Response to Comments for the Federal Register Notice for the Texas and Oklahoma Regional Haze State Implementation Plans; Interstate Visibility Transport State Implementation Plan to Address Pollution Affecting Visibility and Regional Haze; and Federal Implementation Plan for Regional Haze

Docket No. EPA-R06-OAR-2014-0754

12/9/2015

GUMO Glide Path with Alternative Natural Conditions
(Luminant (0061) Figure 2 and AECOM (0061/0075) Figure 3-6)

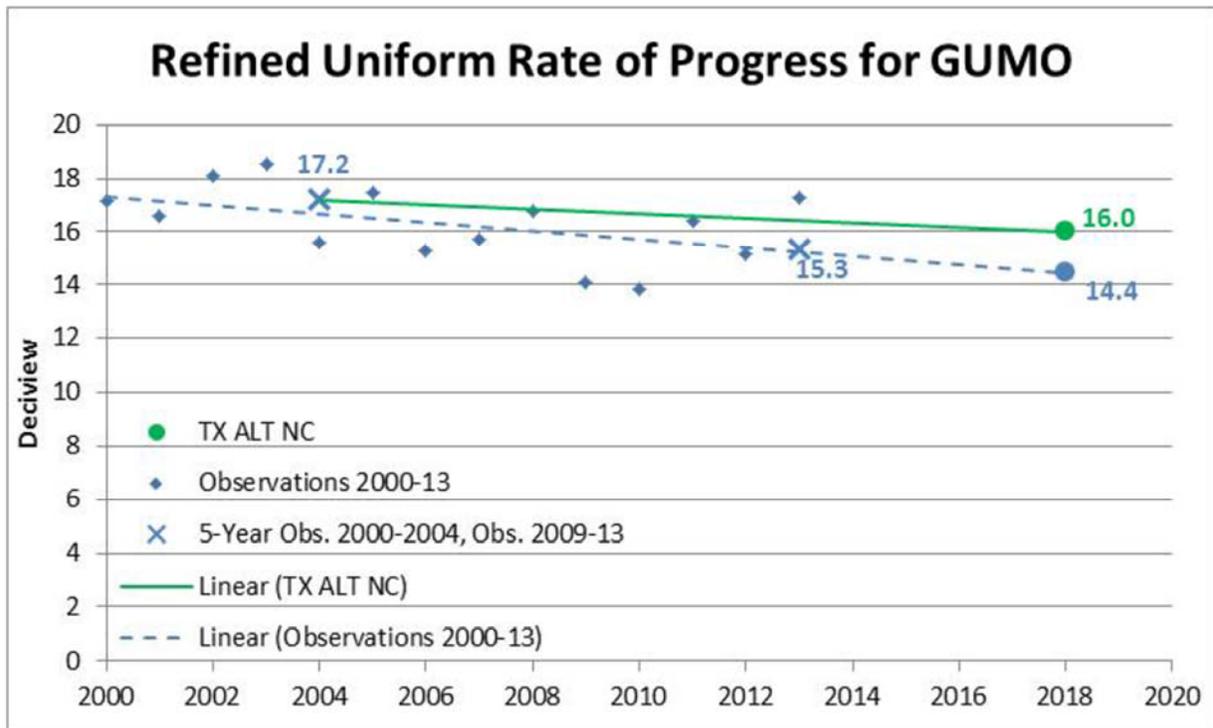
and Figures 3-6 and 3-7 from AECOM 0061/0075) show the resulting uniform glide paths for the two Class I areas using the TX ALT NC results for natural conditions. (Figure 4 from Luminant 0061 and Figures 3-8 from AECOM 0061/0075) is an alternate figure shown for BIBE without the anomalous 2011 information included in the regression line. With the TX ALT NC values, the new URPs for 2018 become 16.01 dv for GUMO and 15.42 dv for BIBE. Using these adjusted natural condition end points and the associated glide paths, it is apparent that the 2018 URP goals will be met for GUMO based on the current IMPROVE measurements' linear regression. BIBE will also meet the revised glide path, and this does not factor in uncontrollable international emissions from Mexico (more discussion on this issue is provided below). Thus, the weight of evidence indicates that with appropriate adjustments and based on the current visibility data, the 2018 URPs will be met for all three Class I areas under consideration in EPA's proposed rule.

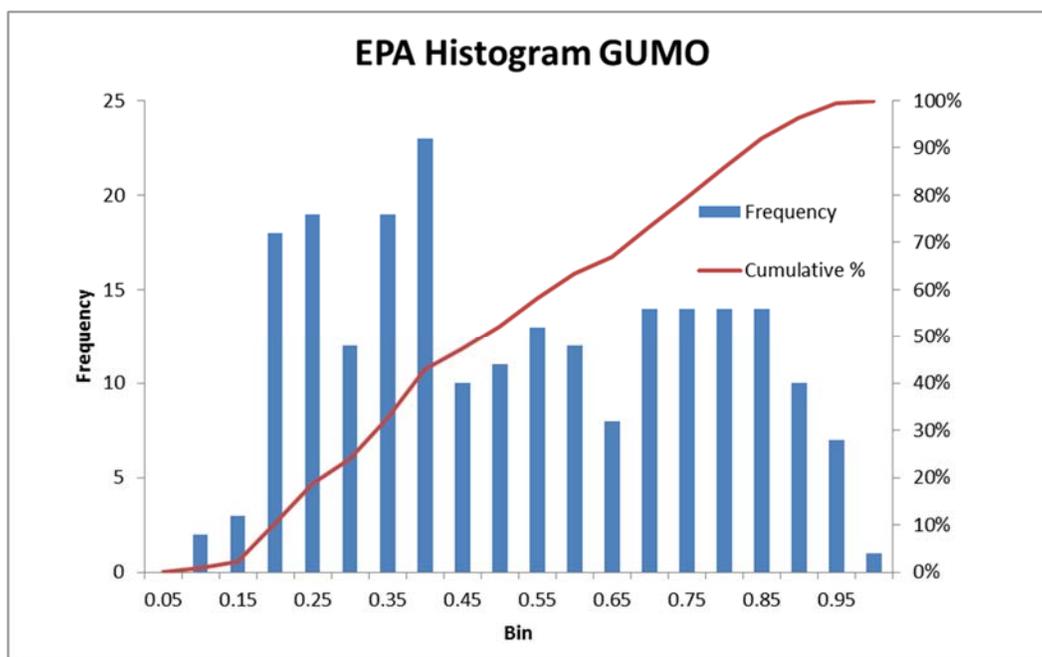
As an initial matter, we believe that AECOM erred in assembling its histograms. This can be readily detected by ordering the bCOS/abext values in AECOM’s spreadsheet,³⁵³ and counting the number of occurrences within the ranges AECOM defined. For instance, there is one value (0.044) in the 0 to 0.05 range, two values (0.084 and 0.086) in the 0.05 to 0.10 range, and 15 values (0.103, 0.106, 0.113, 0.116, 0.117, 0.120, 0.121, 0.128, 0.129, 0.130, 0.135, 0.138, 0.144, 0.145, and 0.148) in the 0.10 to 0.15 range. We have constructed corrected histograms and reproduce them below.³⁵⁴

³⁵⁴ Our corrected histograms appear in tab “EPA Histograms” in our reworked version of AECOM’s spreadsheet, entitled, “Copy_of_AECOM_improve_2000-13_EPA.xlsx,” which is in our final docket.

FIGURE 10: BACK TRAJECTORIES ON THE 20% WORST DAYS FOR BIG BEND, 2011-2013

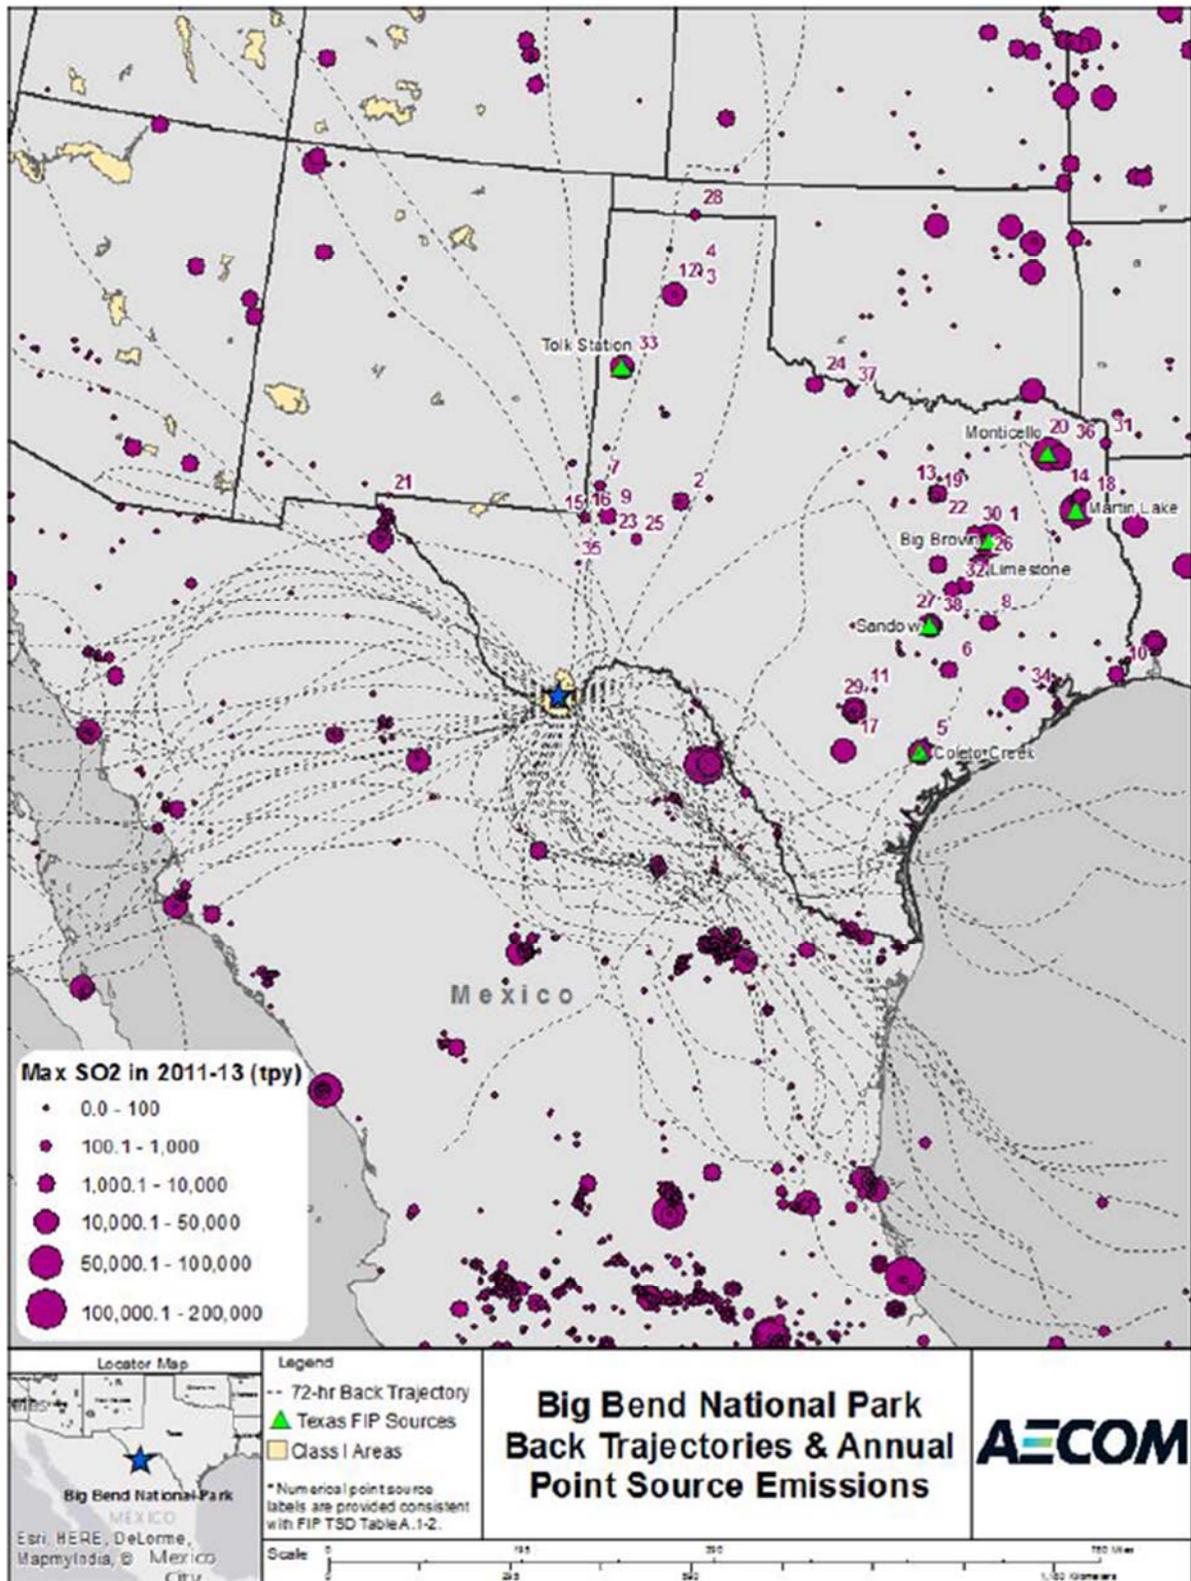
AECOM Figure 4-2 shows the back trajectories at BIBE from 2011-2013 on the 20% worst days. The 38 facilities in Texas that were modeled by EPA are labeled in the map. The back trajectories illustrate that BIBE most often experienced air from the west, south, and southeast transport regimes. The most recent facility-aggregated point source SO₂ emissions for Texas and

In contrast, trajectories indicate that emissions from Mexico, particularly the facilities such as Carbon I and Carbon II on the Texas/Mexico border, heavily influenced BIBE haze conditions. These point sources stand out as large emitters just southeast of BIBE and only 230 km away. Trajectories from the west and south further indicate the transport of natural dust events from the Chihuahuan Desert and/or fire activity. For example, as shown in AECOM Figure 4-3 in comment 0061/0075, one of the top five worst haze days (April 21, 2011) indicated southerly to southwesterly transport which brought in smoke from wildfires. As noted previously, TCEQ has identified numerous dust and fire events, particularly in 2011, that adversely influenced particulate matter measurements. Furthermore, a recent long-term dust event climatology identified 16 local dust events during 2000-2007 that specifically affected BIBE.⁸⁰ According to the 2011 NEI (version 1), wildfires in 2011 in Texas alone account for approximately 188,970 tons of PM_{2.5} and 222,985 tons of PM₁₀.⁸¹ These statistics further support the TX ALT NC natural conditions presented above.

FIGURE 11: BACK TRAJECTORIES ON THE 20% WORST DAYS FOR GUADALUPE MOUNTAINS, 2011-2013

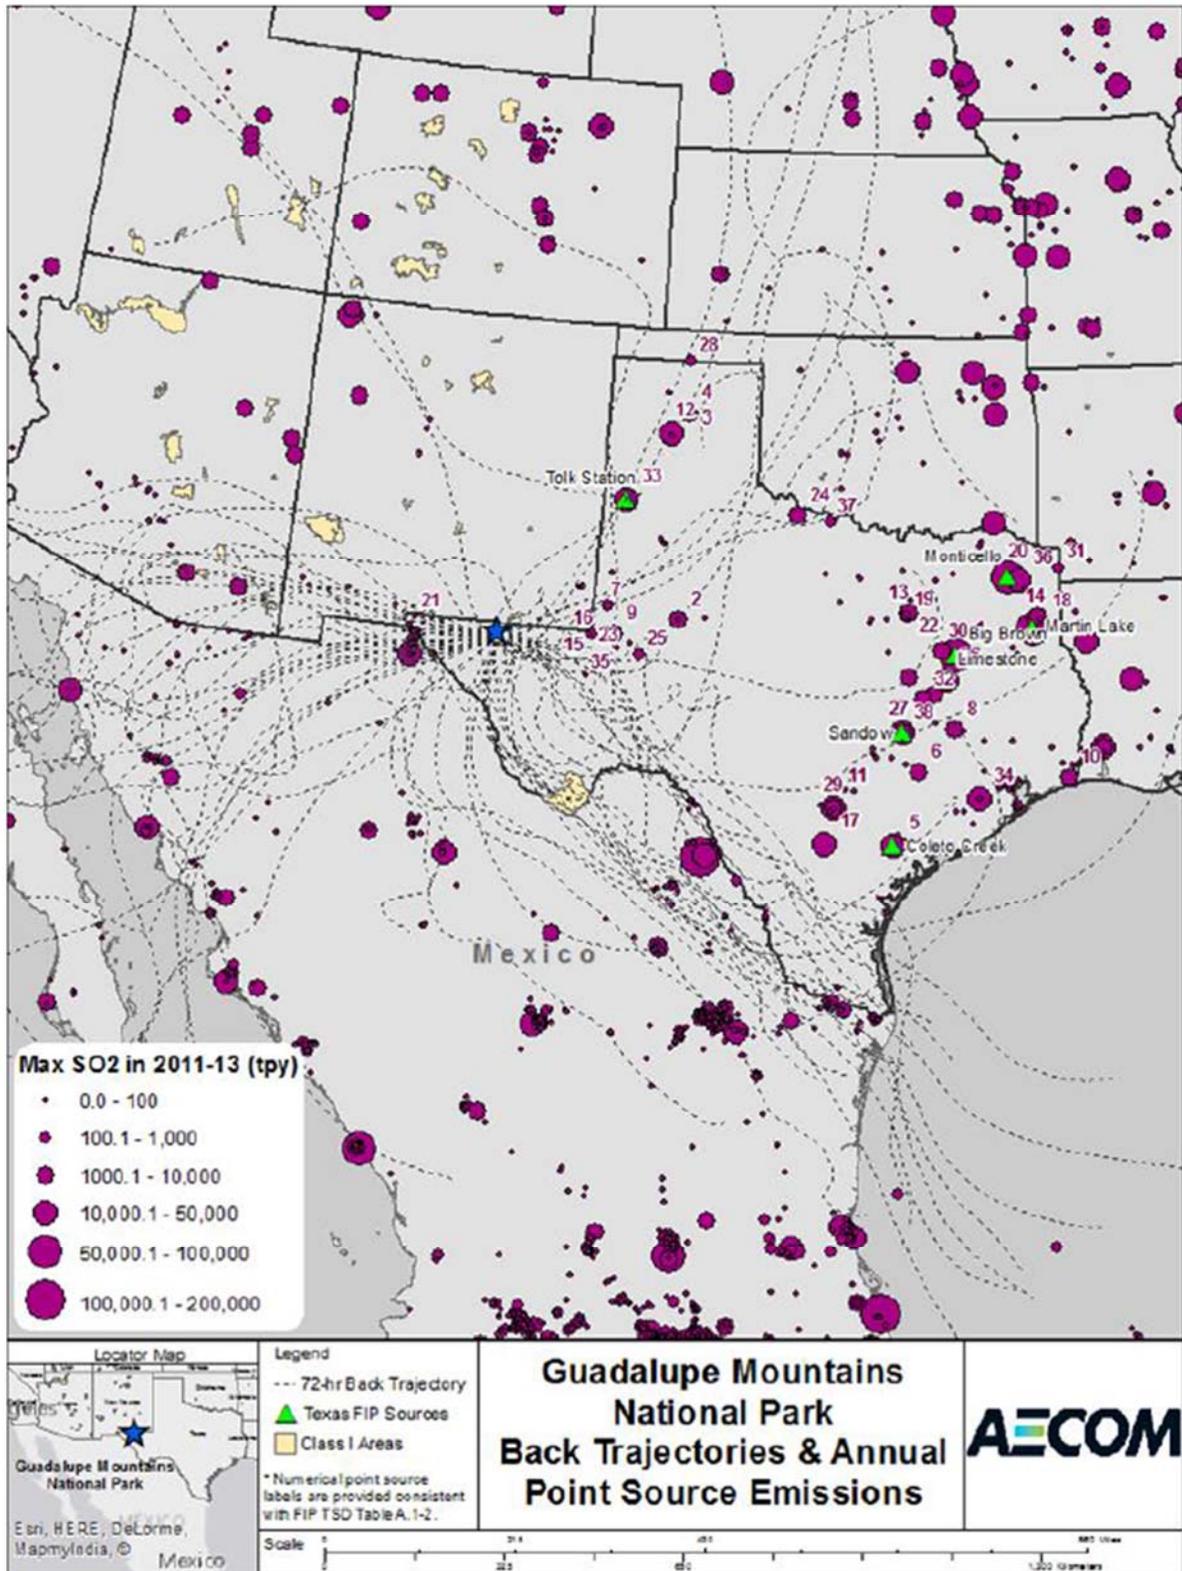
Similar to BIBE, as shown in AECOM Figure 4-5, back trajectories to GUMO on the 20% worst days show that GUMO's haze conditions were influenced by west, south, and southeast transport regimes. GUMO infrequently experienced northeasterly transport from the direction of the facilities targeted in EPA's proposed FIP during the 20% worst haze days where 21 out of 66 (approximately 32%) trajectories originated from the Texas FIP sources. The farthest distance a trajectory must travel to reach a Texas facility with a proposed new emission limit is approximately 960 km away from GUMO. Like the approach taken with BIBE, the trajectory uncertainty of 22.5% was used. Thus, 22.5% of 960 km is about 216 km. With this procedure, we find that only 8 trajectories (about 12%) originated from within 182 km of Coletto Creek (22.5% of 800 km), and we find that only 5 trajectories (about 8%) originated from within 216 km of a Luminant facility.

Natural Breaks for% Extinction on W20% Days at the Most Impacted Area Based on Jenks' Optimization (Figure 5 provided by Xcel Energy)

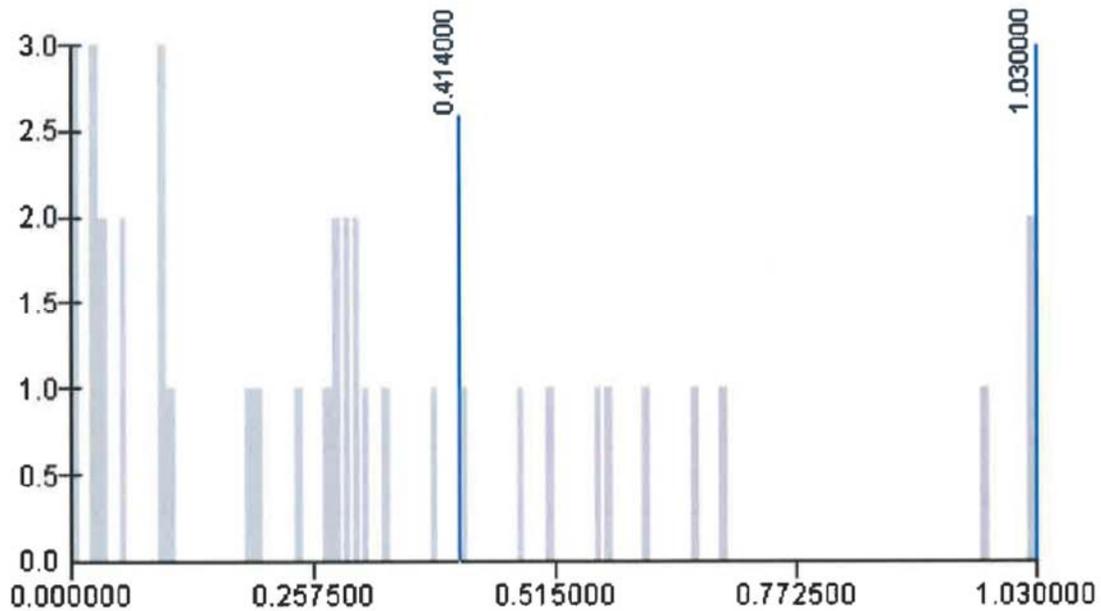
As shown in Exhibit __ (Xcel Energy Figure 5) above, Jenks' optimization, a statistically sound method that is appropriate to the dataset, would set the natural break for including sources in the group subject to the reasonable progress four-factor analysis at 0.41 %. EPA's utilization of a threshold of 0.3% extinction to determine which units should be included in a reasonable progress four-factor analysis is unjustified and its selection appears to be subjective. It results in an arbitrary threshold specific to this data set that cannot be applied or replicated across other reasonable progress analyses.

**Total Percent Contribution to 2018 Total Light Extinction at Guadalupe Mountains, W20
Group (Figure 3 provided by Xcel Energy (comment 0064))**

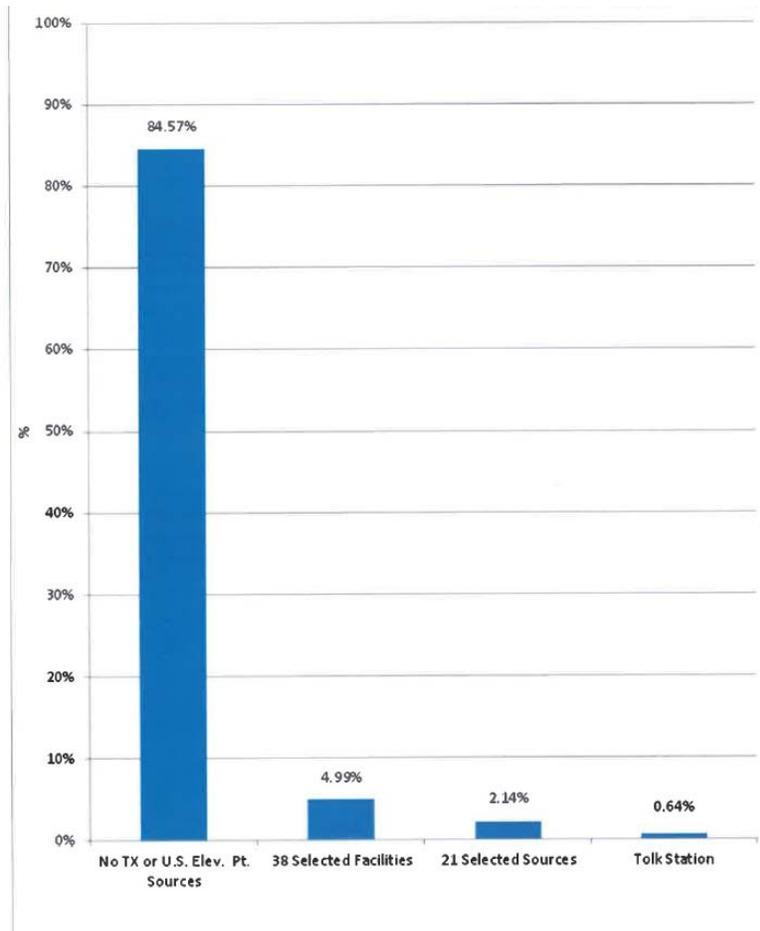
(Xcel Energy Figure 3) displays the percent contribution to total 2018 light extinction at the Guadalupe Mountains. These percentage contribution values were calculated based on the collective contribution to light extinction by each source group as compared to the 2018 baseline total extinction value. Here, again, the visibility effects of the EPA selected 21 sources are miniscule in light of the contribution of international sources and natural contributions.

Figure 2-2: Projected Texas SO₂ and NO_x EGU Emissions Trend through 2018³⁶

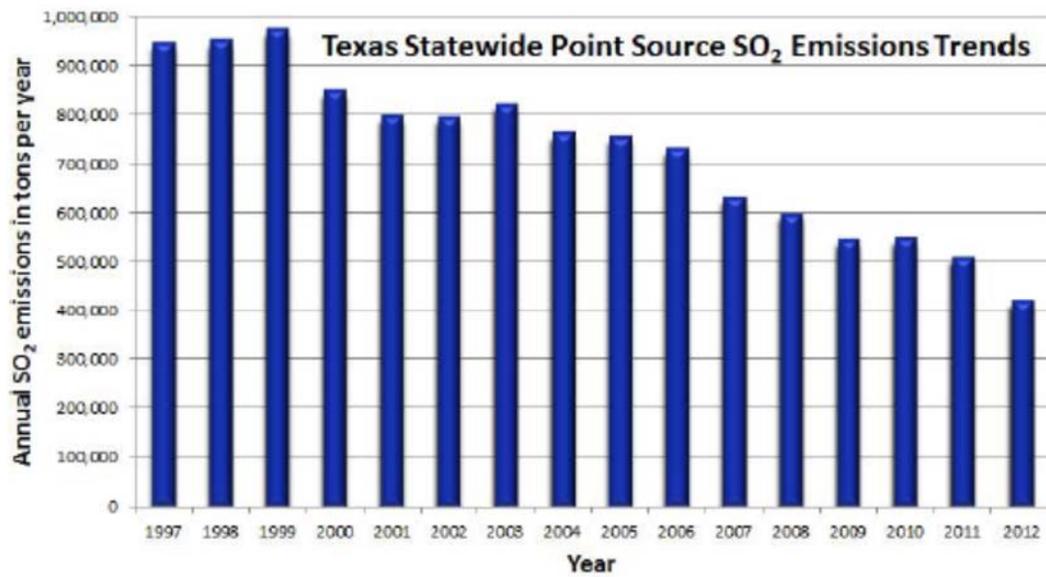
AECOM (0075) stated that actual SO₂ emissions from Texas have been significantly reduced since the regional haze rule baseline period (2000-2004). As noted by the TCEQ,³² statewide SO₂ emissions had decreased by nearly 50% from the baseline period through 2012, as shown in AECOM (0061/0075) Figure 2-1). The Texas 5-year regional haze progress report³³ issued in 2014 indicates a projection of further reductions of haze-forming SO₂ and NO_x emissions from point sources through 2018 (Figure 2-2 of AECOM 0061/0075). Therefore, it is expected that visibility improvements observed through 2013, as discussed below for WIMO, GUMO, and BIBE, will continue through the 2018 interim goal year.

Annual SO₂ Emission Trends - Texas. (Alpine Figure 13 (0078))

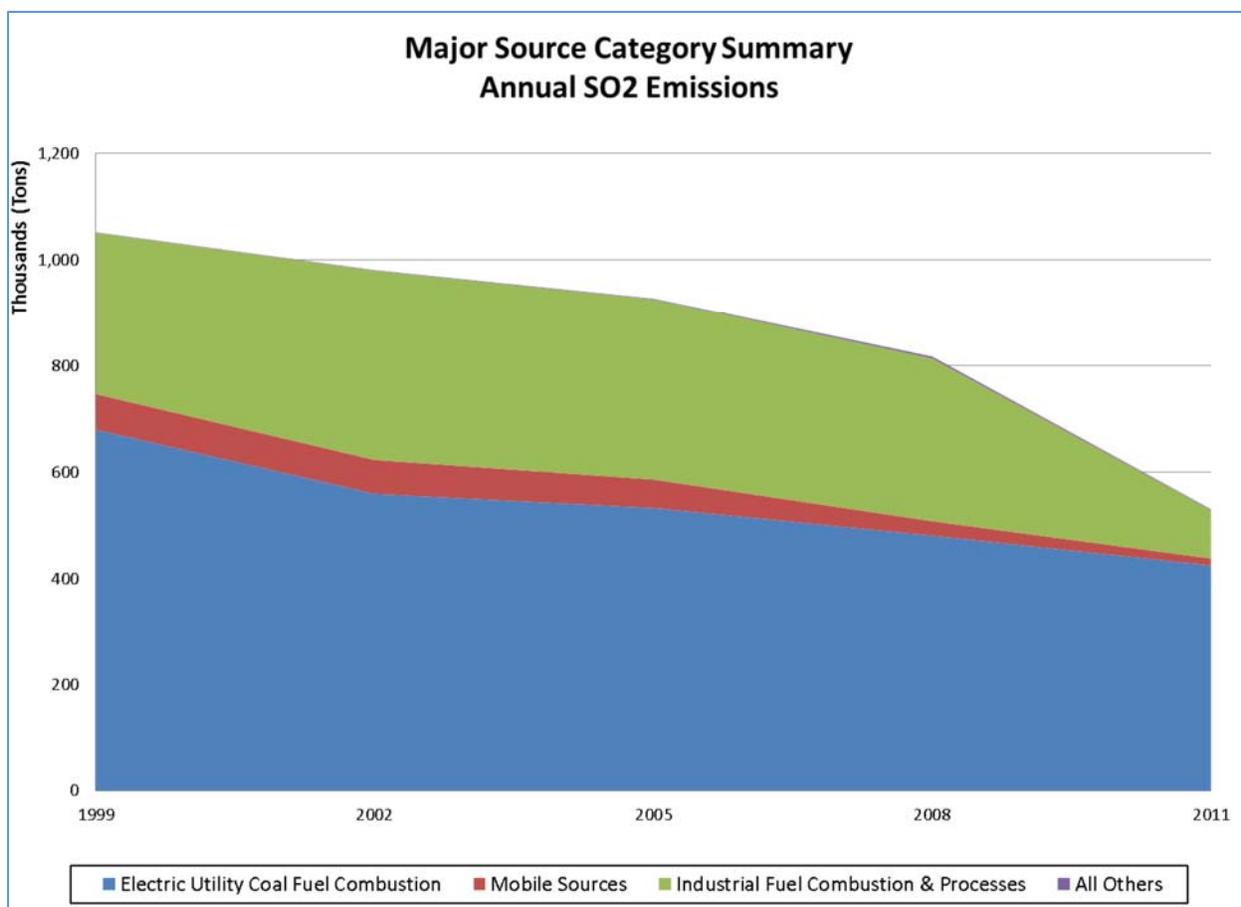
[Alpine (0078) p. 22] Alpine concurred with EPA's findings that this observed improvement from the baseline conditions is the result of reduction in the impacts from SO₂ emissions and a reduction in the impacts from coarse material but disagreed that it is related to meteorological conditions more than emission changes. Alpine provided Figure 13 showing SO₂ emissions in Texas from 1999 through 2011 and noted that a reduction of 50% in SO₂ emission has occurred across all anthropogenic categories State-wide. A significant portion of this reduction is attributed to electric utility coal fuel combustion (38%), as well as from industrial fuel combustion and processes (70%). And according to TCEQ's point source emission inventory, these values continue to decrease beyond 2011 levels for all point sources reporting to the State.⁷
